Hurricane Planning Commission Meeting Agenda

June 12, 2025
6:00 PM

Agenda Date:	06/12/2025 - Planning Commission
Application Number:	ZC25-14
Type of Application:	Zone Change Amendment
Action Type:	Legislative
Applicant:	Michael and Aimee Carnell
Agent:	
Request:	Approval of a Zone Change from R1-15 to General Commercial (GC).
Location:	2085 S 700 W
Zoning:	Single Family Residential R1-15
General Plan Map:	Single Family
Recommendation:	Recommend approval to the City Council.
Report Prepared by:	Fred Resch III

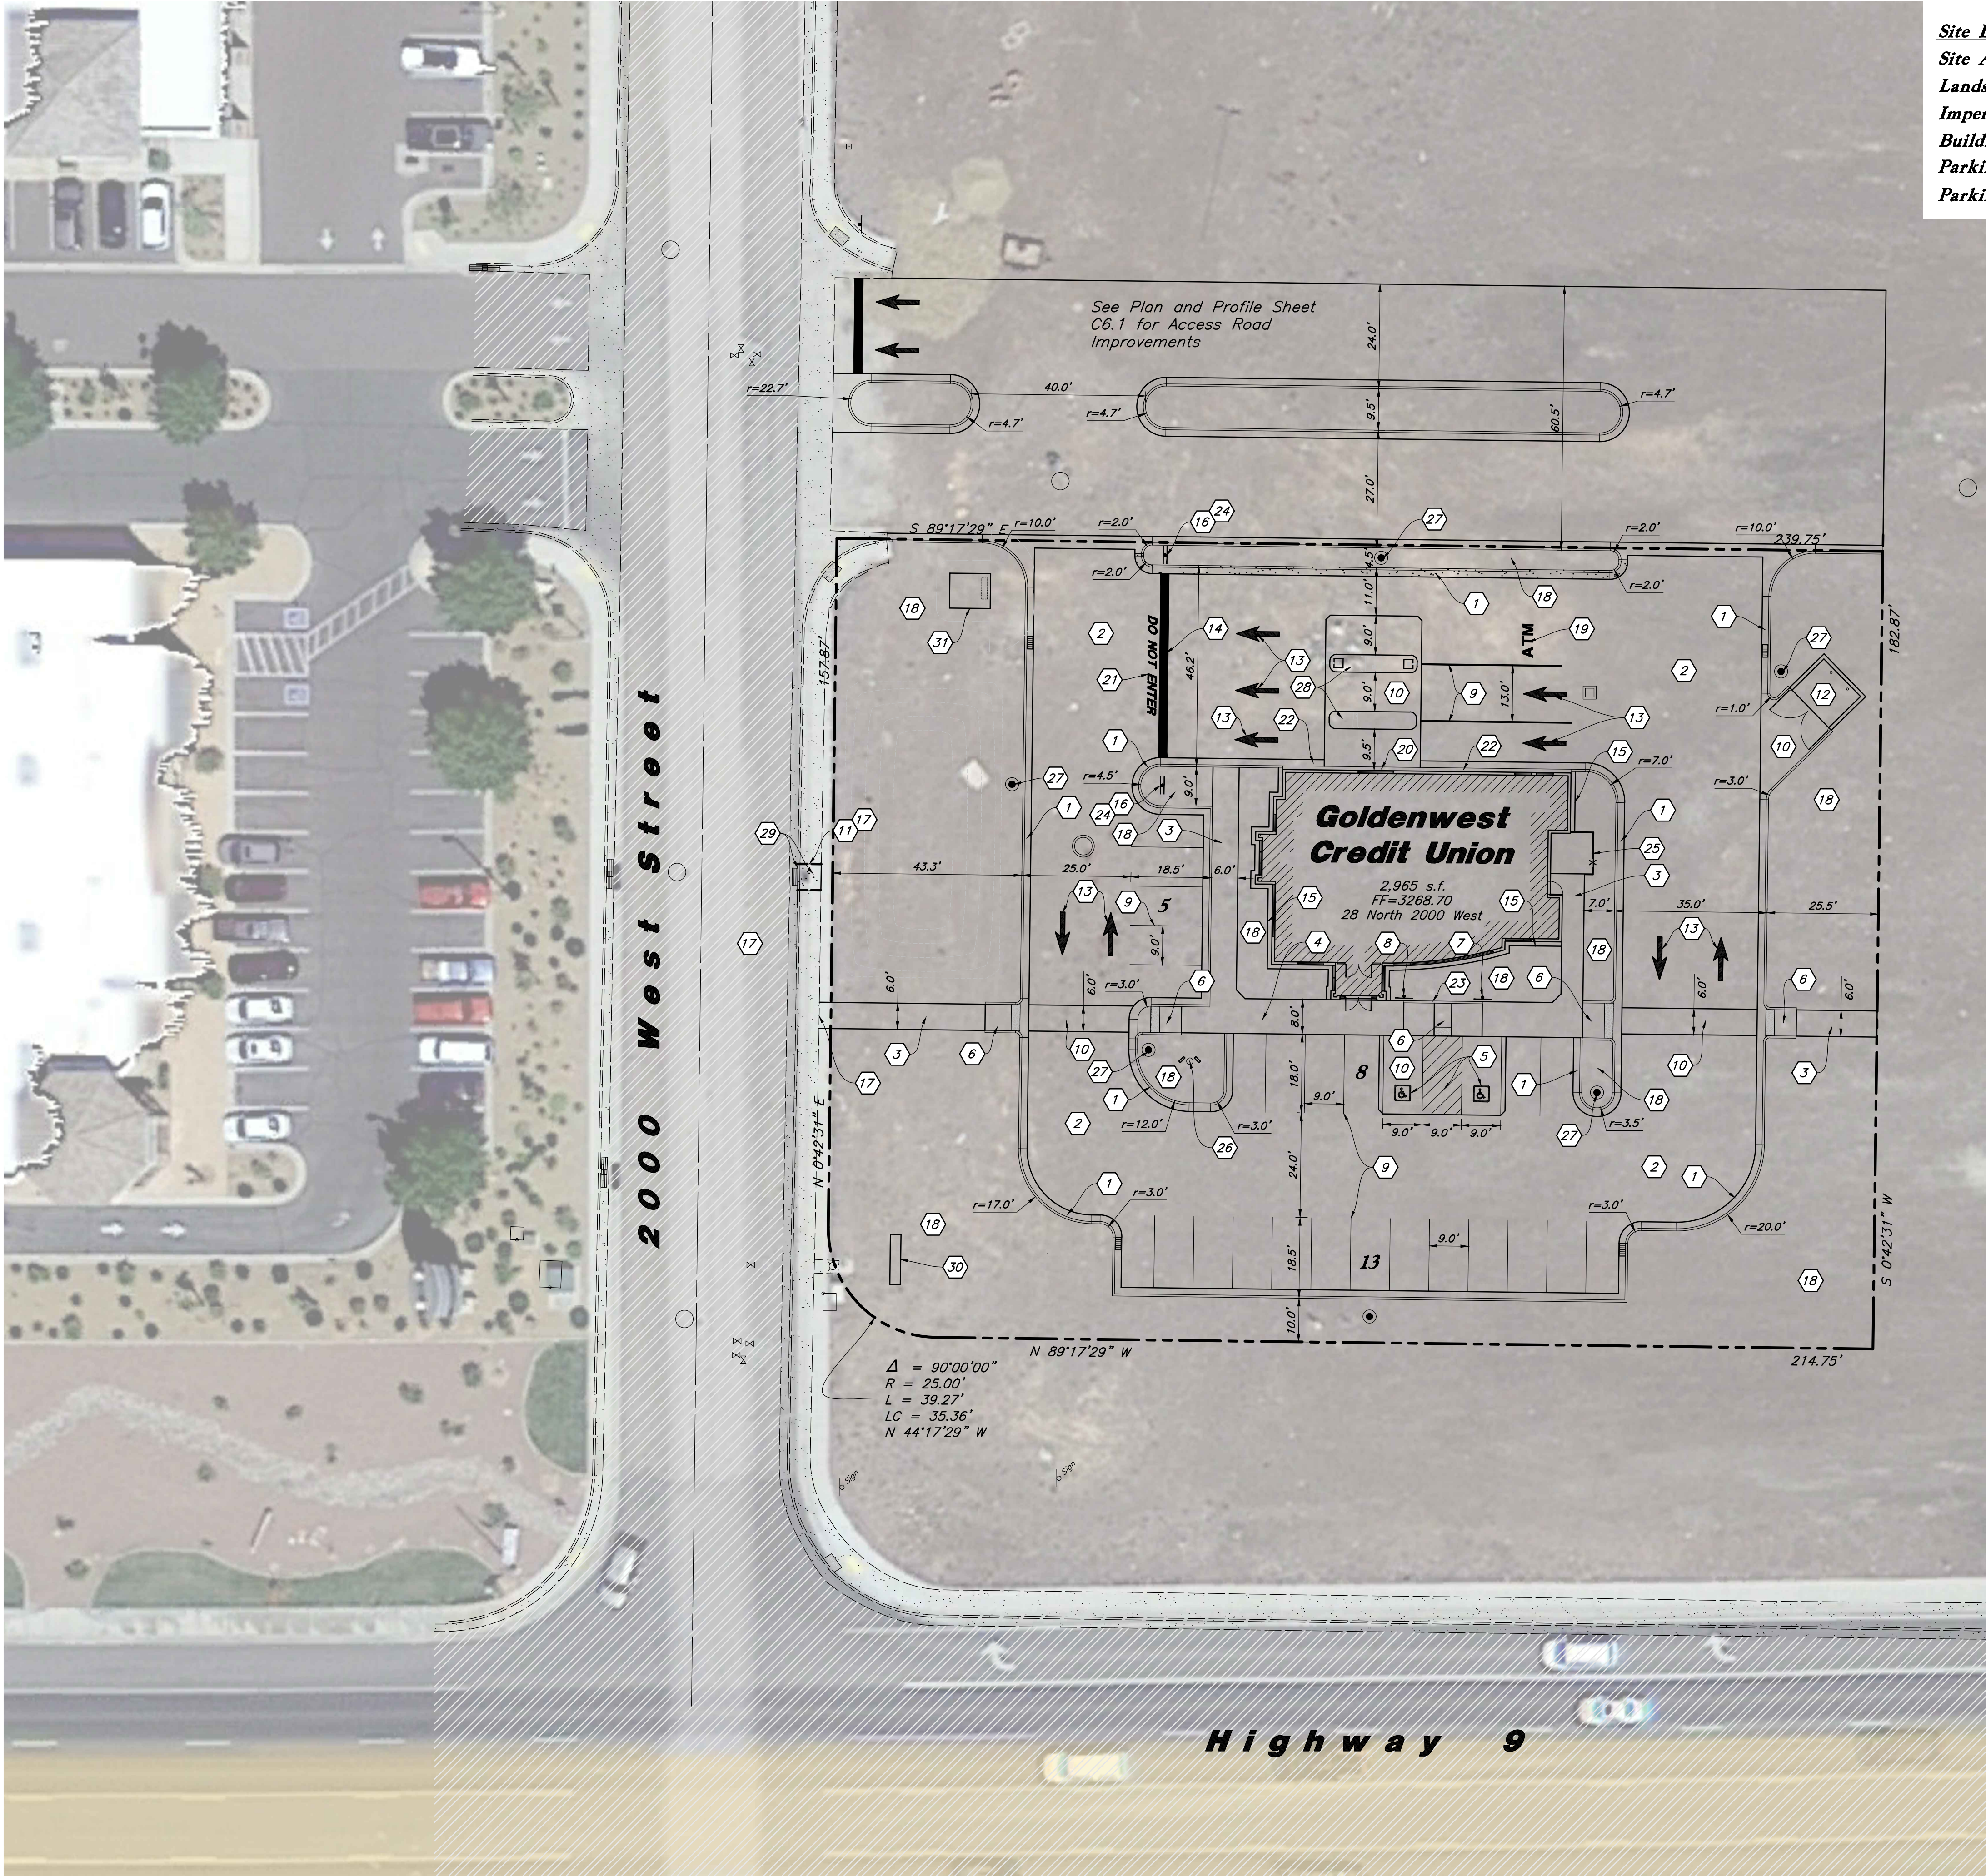
Additional HCC 10-34-6(D)(1) requires that stacking space for three cars per lane be provided. While it appears stacking space has been provided, it is not clear from the exhibit if this space is adequate. This will need to be clarified with the final site plan.

3. Landscape: A landscaping plan has been submitted. Landscaping in the UDOT property between State St and this property should be added.
4. The proposed monument sign will need a separate sign permit.
5. The site plan shows, and staff appreciates, the additional sidewalk connectivity through the site. As mentioned in Engineering's comments (JUC #6) a sidewalk connection to State St may be better for connectivity for the whole region.
6. No Vested Rights: *A preliminary site plan is not intended to permit actual development of property pursuant to such a plan but shall be prepared merely to represent how the property could be developed. Submittal, review, and approval of an application for a preliminary site plan shall not create any vested rights to development.* (see Hurricane City Code 10-7-10 (D)(2)(b)).

Recommendation: The Planning Commission should review this application based on the standards within the Hurricane City Code. Staff recommends approval of the preliminary site plan subject to staff and JUC comments.

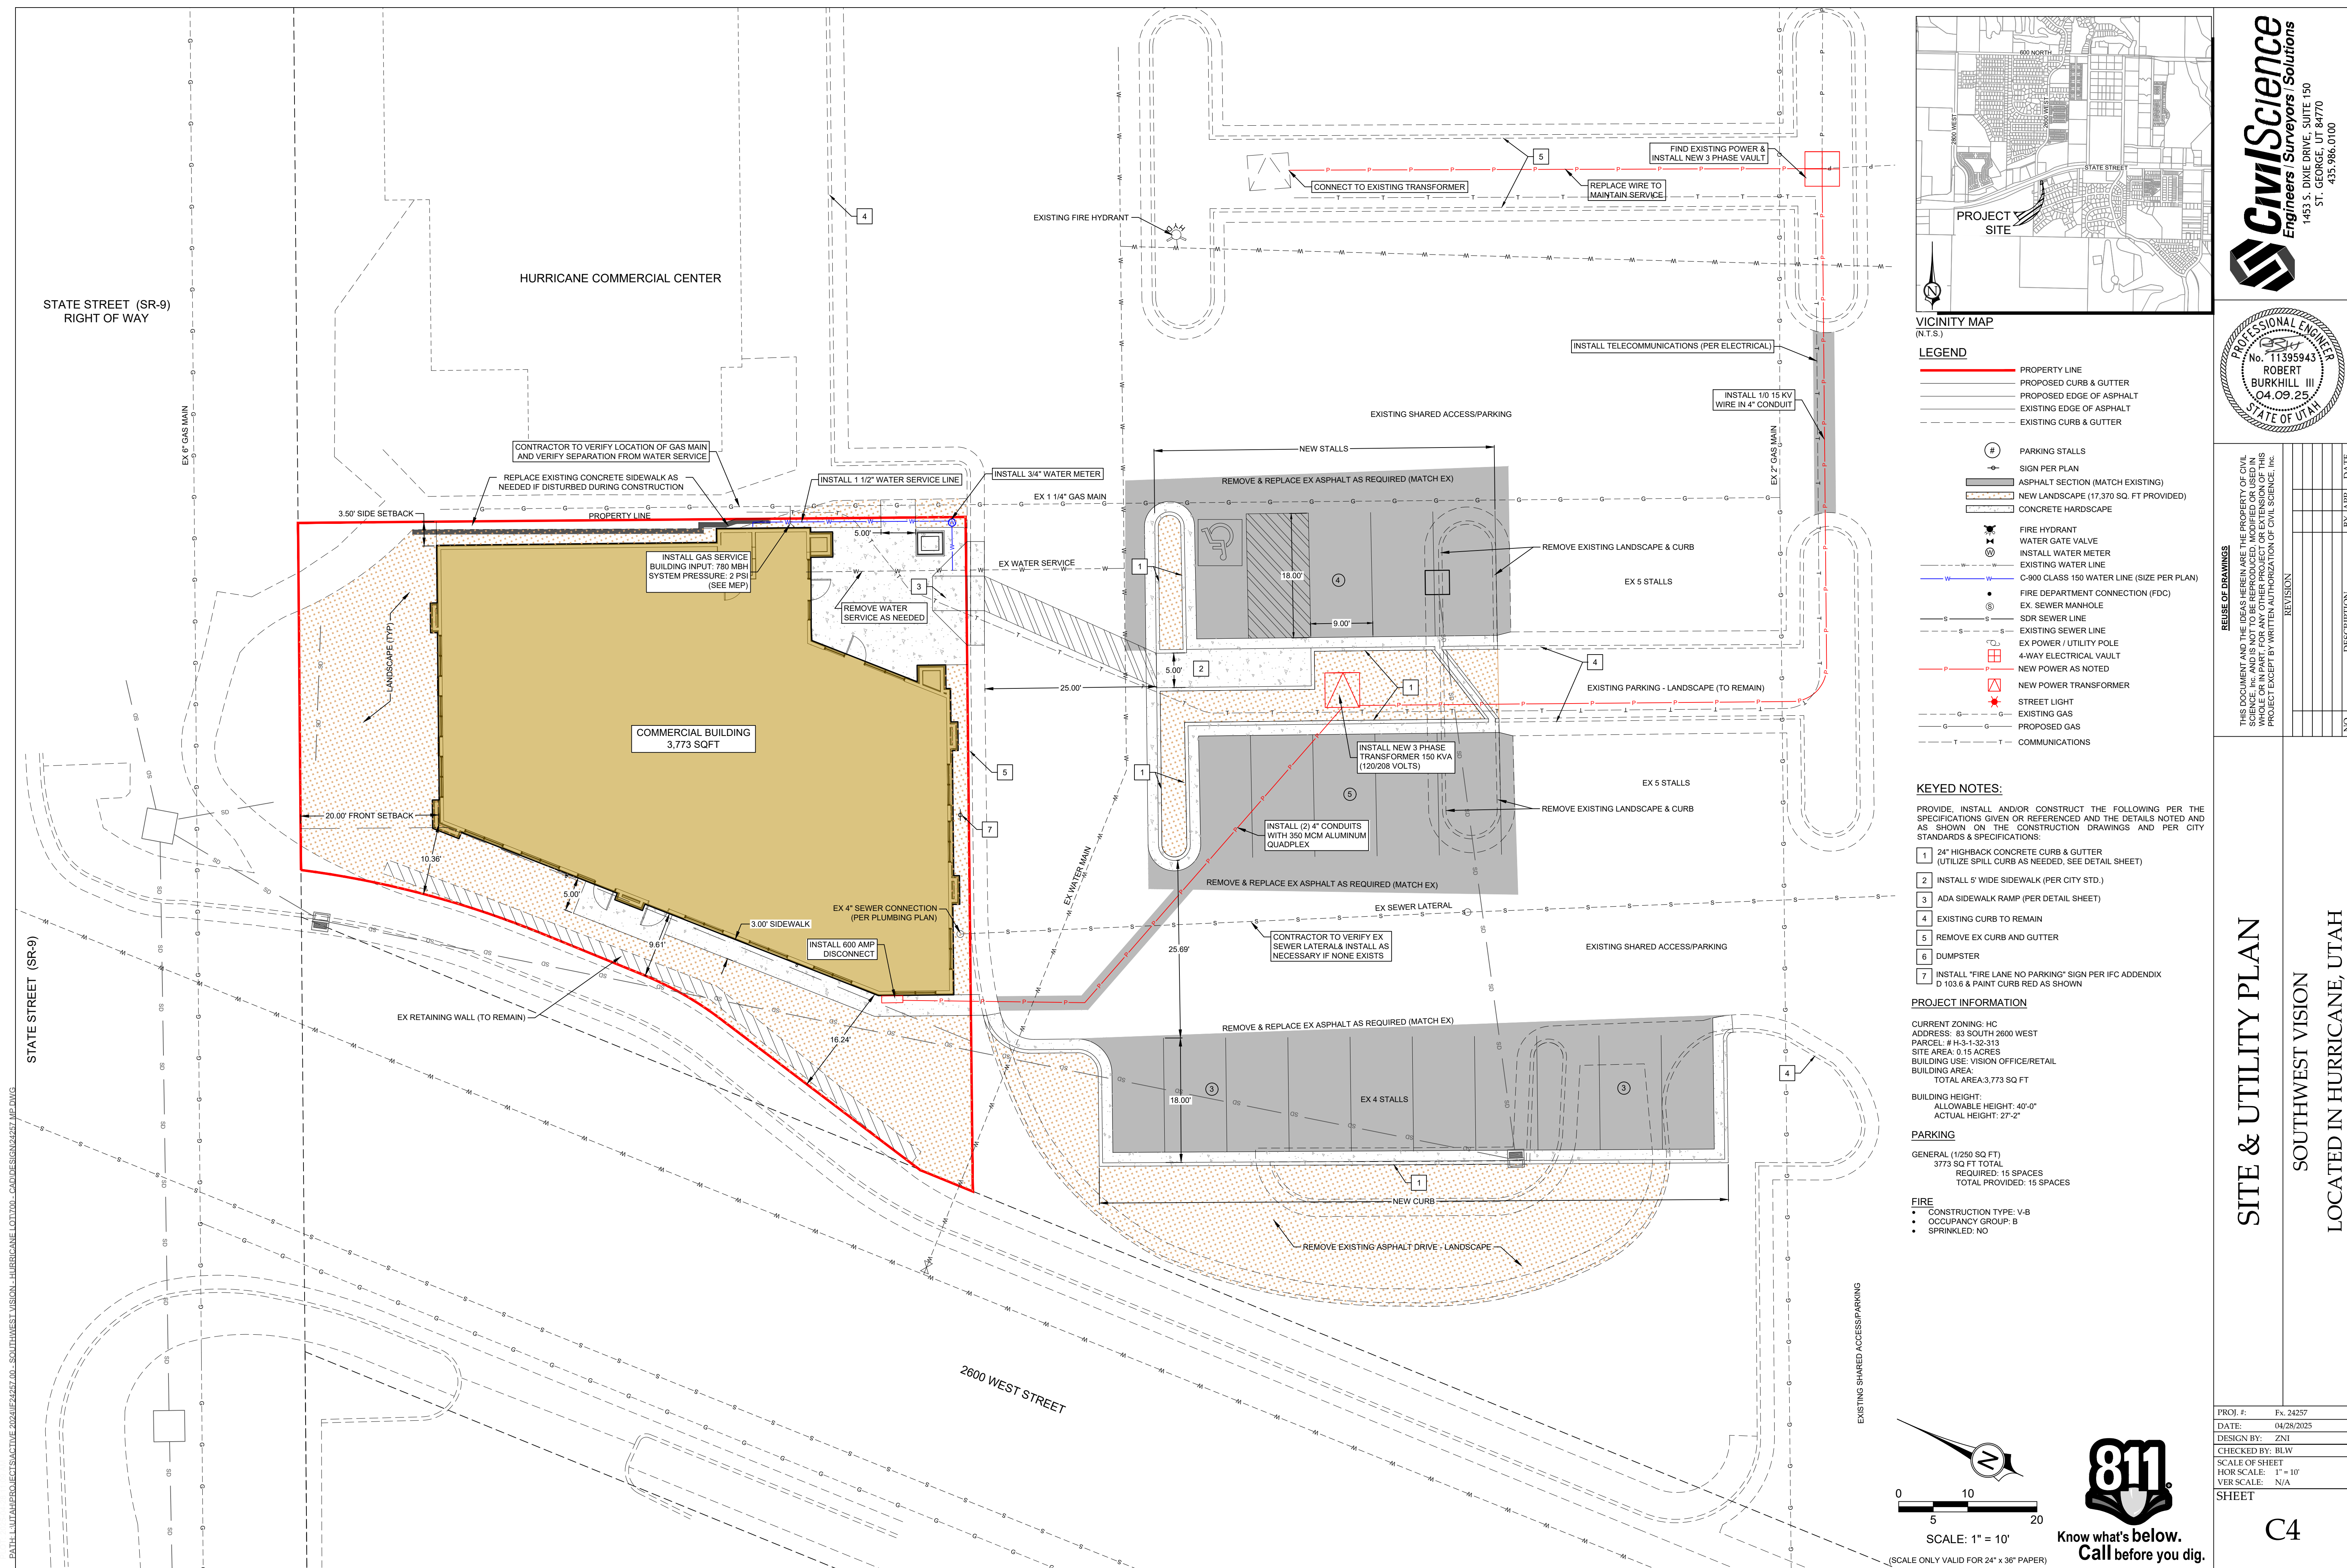
5. Outdoor lighting: The applicant has stated they do not intend to install any new outdoor lighting. Any new outdoor lighting needs to meet HCC 10-33-7.

6. Building renderings have been submitted, staff has no concerns with the renderings presented as the building will be under 35' tall.

Recommendation: The Planning Commission should review this application based on standards within the Hurricane City Code. Staff recommends approval of the final site plan and the landscape deviation request subject to the recording of the amended final plat for Hurricane Commercial Center, and subject to staff and JUC comments.
